July 22, 2016

**SUBJECT:** AMENDMENT PLAN – 600 Righters Ferry Road, The Royal Athena, Bala Cynwyd, LD# 3683A, Ward 9. *Christopher Leswing*

The applicant, Kevin Kyle, of Righters Ferry Associates, LP (RFA), is seeking **Amendment Plan** approval to reconfigure the approved public gathering space and plaza areas and the removal of nine (9) parking spaces.

Previously Approved Area

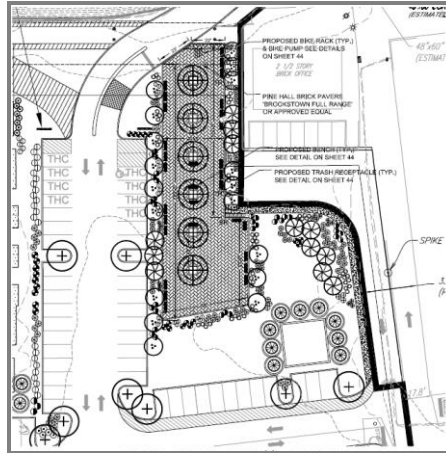
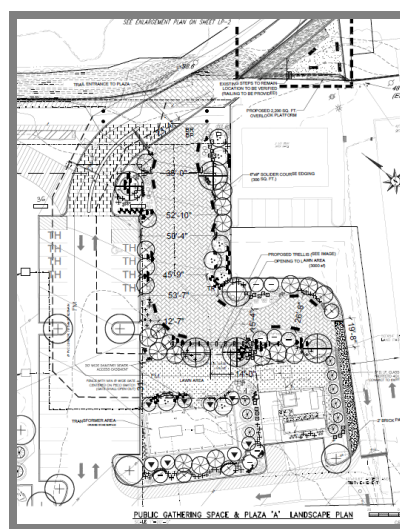
The size and quality of the public gathering spaces have been impacted by the installation of the PECO transformers. Staff has worked with the applicant to redesign the public space to minimize the visual effect that both the elevated transformers and the pump house have on the space, with the goal of creating an attractive space for residents and users of the trail to gather and engage in recreational activities. The public gathering space has been extended to include an area that is cantilevered over the river and which connects to the Pencoyd bridge. Staff observed that the applicant recently installed a significant amount of chain-link fencing in this area and notes that a condition of approval required the removal of all chain-link fencing from the site. Therefore, staff recommends that the chain-link fencing in this area be removed as well.

In an effort to reduce the visual impact of the utilities on the space and create a direct pedestrian connection to and through the space, the applicant has reoriented the space from a linear to a more curvilinear design. The applicant has also included screening elements around the transformers such as a fencing and a trellis. Staff recommends four parking spaces located along the internal access driveway be removed to allow for additional landscape screening along the western side of the transformers.

An important element of the location of the public gathering space is that it connects significant elements on the site including the public pedestrian access to the bridge and the public trail. The redesign provides an improved bike and pedestrian connection from the Pencoyd Bridge to Righters Ferry Road and an existing gate leading to West Laurel Hill Cemetery, which connects to the Cynwyd Heritage Trail. Staff would like to ensure that the pedestrian connections to this space are provided. Staff has included a condition requiring the applicant to continue to work with staff to provide the appropriate connections, including linking the space with Righters Ferry Road and making the space ADA accessible by adding a ramp from the public trail.

1. The new public gathering space connected to the Pencoyd Bridge shall be made ADA accessible by adding a ramp from the public trail. The applicant shall work with staff on final design of the space.

2. All chain-link fence shall be replaced with appropriate architectural fencing. The applicant shall work with staff on the final design of all fencing.

3. Pedestrian striping shall be added along the access driveway to areas adjacent to the proposed Public Gathering Space/Plaza A as directed by the Township Engineer.

4. Landscaping between the Public Gathering Space/Plaza A and the transformers shall be increased in size from 8'-10' to 10'-12' for evergreens and from 2-2½" to 2½-3" for deciduous trees.

5. The applicant shall remove the four parking spaces located adjacent to the transformer and provide additional landscape screening along the western elevation.

### 2. Plaza Areas

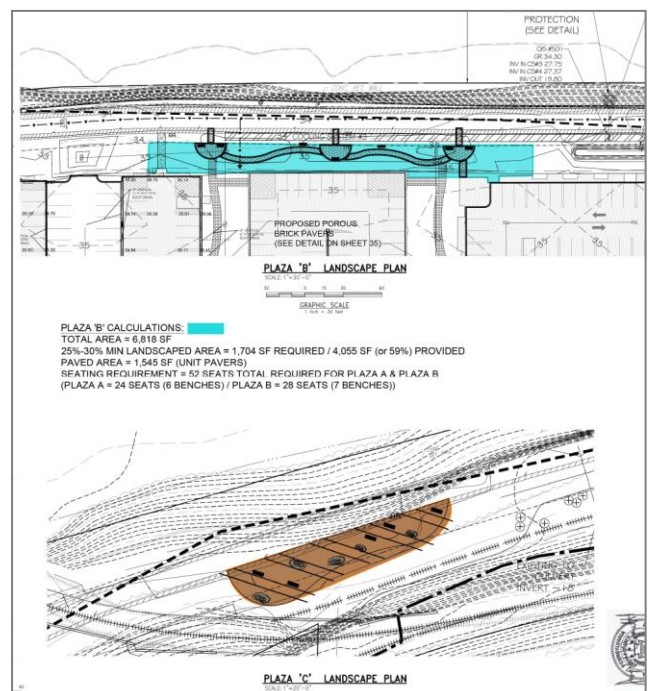
The approved plan showed two Plaza areas (Plaza A & Plaza B) and the proposed plan creates a third plaza area. Plaza A is located adjacent to the public gathering spaces, Plaza B is located adjacent to the trail and new Plaza C is located along the western portion of the property adjacent to the tow path bridge.

Plaza C is located in an underutilized portion of the site and incorporates railroad ties, a nod to the property's historical railroad connection which also meets a condition of approval requiring the

applicant to incorporate industrial material from the site.
